MEETING NOTES

Meeting Date & Time: Thursday, December 22, 2016 – 8:00am – 9:30am
DFD Project Number: 14120
Project: Wittich Hall Renovation
Location: 150 Murphy
Purpose: Site / Civil / Utilities

The purpose of the meeting is to review the site work and civil utilities for the project.

Tree Canopy – Proposed Removal

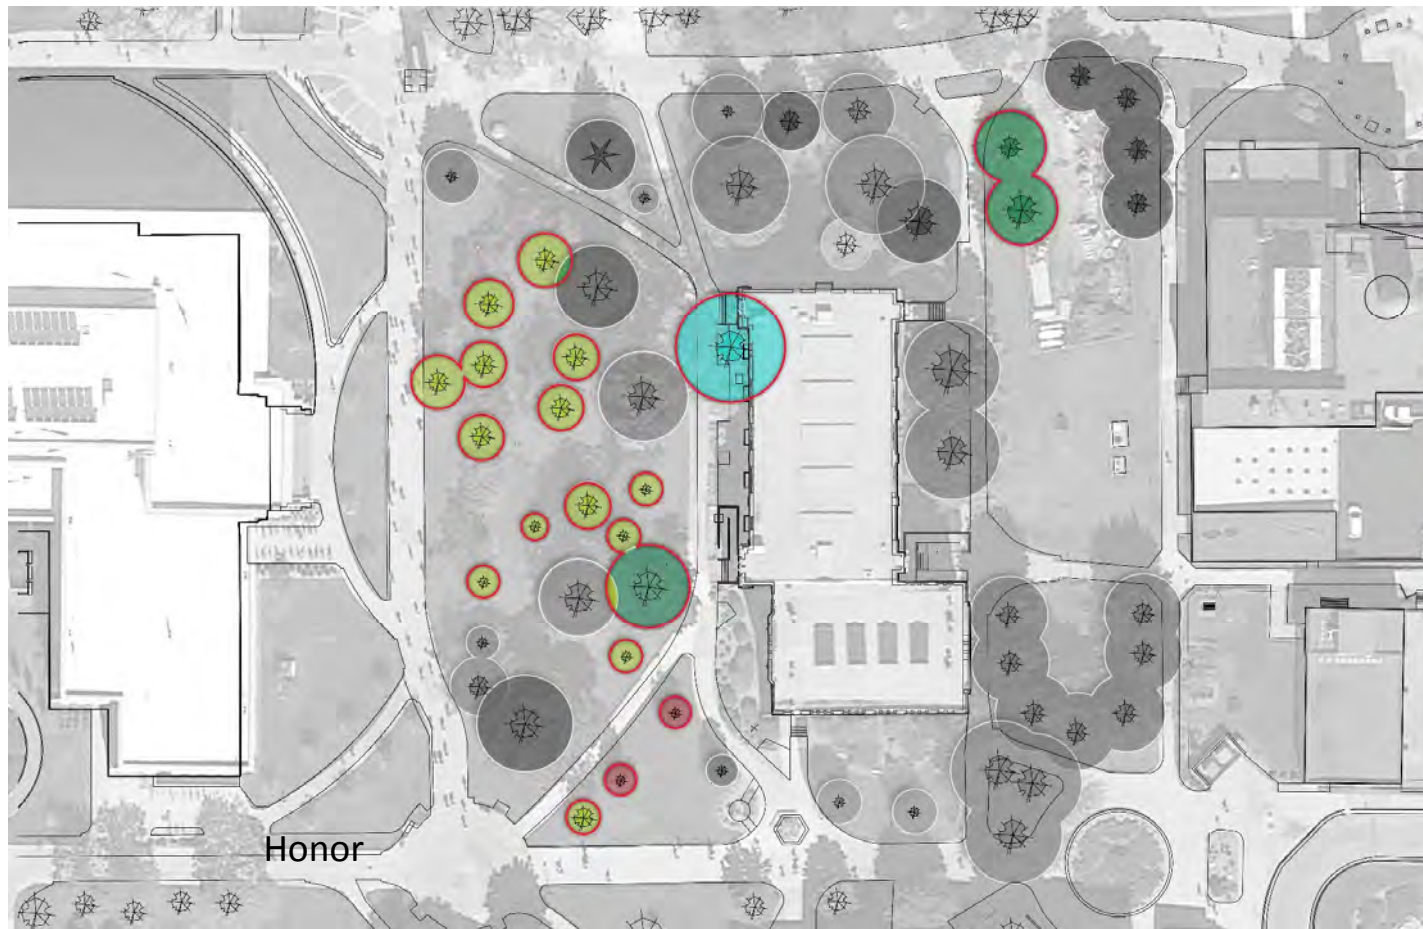
5. Proposed tree removal and remaining trees were reviewed.

Stormwater Constraints

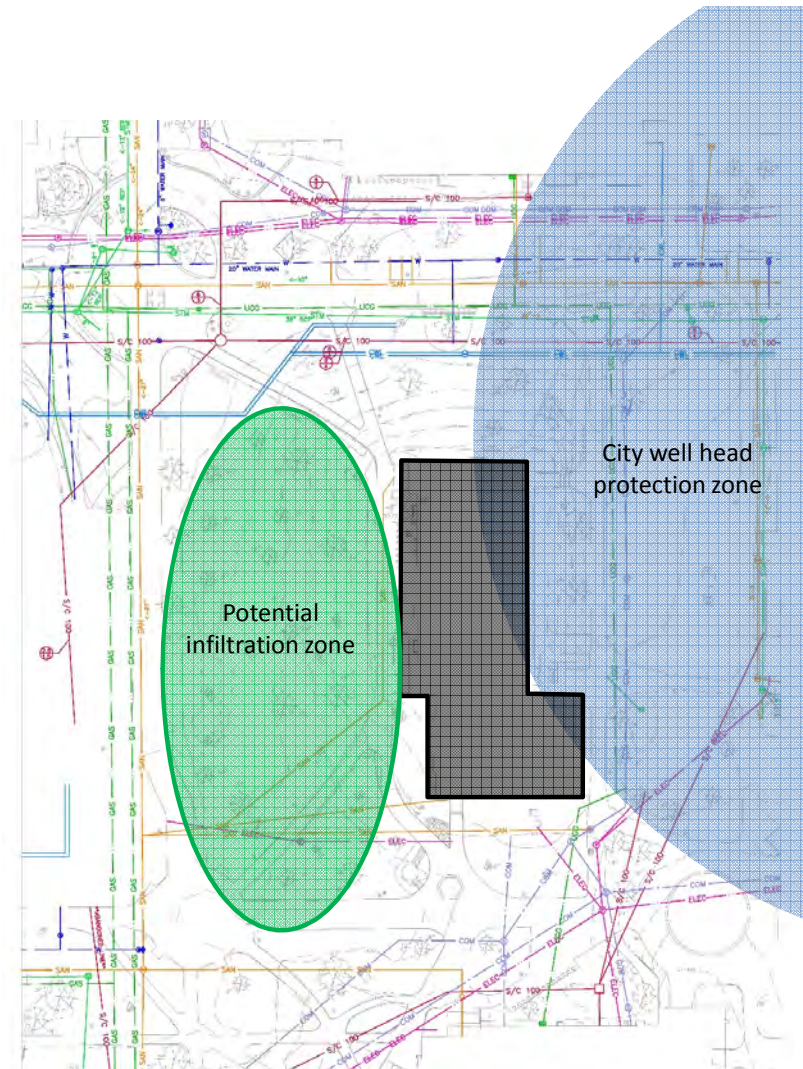
- i. Site Constraints
 1. Well head protection zone to the east of the building.
 2. Limited areas for infiltration.
 3. Coordination with new project for Graff Main Hall.

Updated Site Design

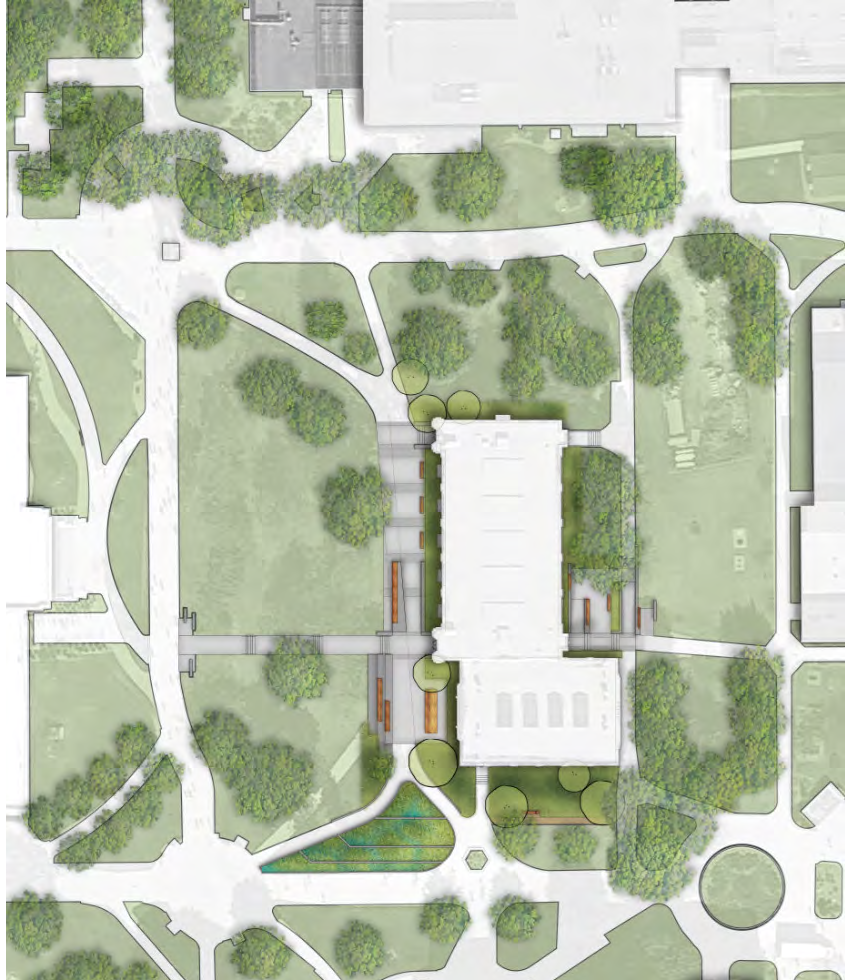
- i. Concept was reviewed by Nathan Hilmer.
- j. West / South
 - i. Southwest entrance was noted as being the primary entry. Southeast entrance will remain as the "historic" entry with seating elements added (similar to the original). Pavement materials were previously discussed (monolithic concrete with varying finish).

- ii. Shifting rain garden from south to west as discussed earlier.
 - iii. Memorial garden location on the south.
 - iv. SE corner will remain as an entry point.

- v. Campus material palette.
 - vi. Scott noted that raised areas may be a concern with code minimum vs making it "dummy proof." Don't want to add railings later. Issue is at primary traffic paths. Raised curb edge is required by ADA. May need to be more than a curb. Seat walls were noted as being fall hazards.

Updated Site Design: East Entrance

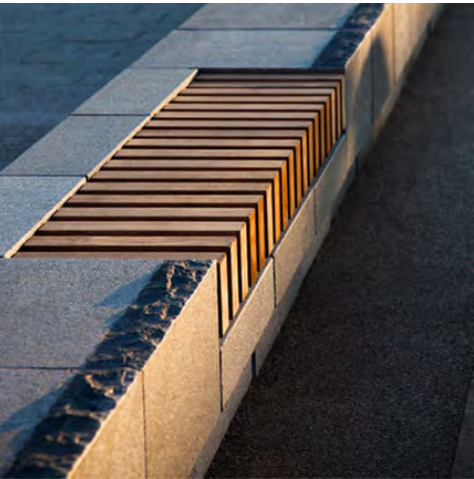
- k. East side
 - i. Concept was reviewed and it includes a modified sloping walk path.
 - ii. It was requested that a 2-3' wide buffer along the east side of the 1930 wing be added. Slide sidewalk east a couple feet. **Action: SmithGroupJJR**

- iii. Integrated wood seating detailing studies were reviewed. Contrasting to the historic building is the overarching concept. Campus noted concern with the longevity with the wood. Grey concrete and wood was noted as not the direction campus wants to go.

- 1. It was requested that the Design Team consider changing material from wood for seat. Review modern detailing to contrast with historic. Campus will not support wood moving forward.
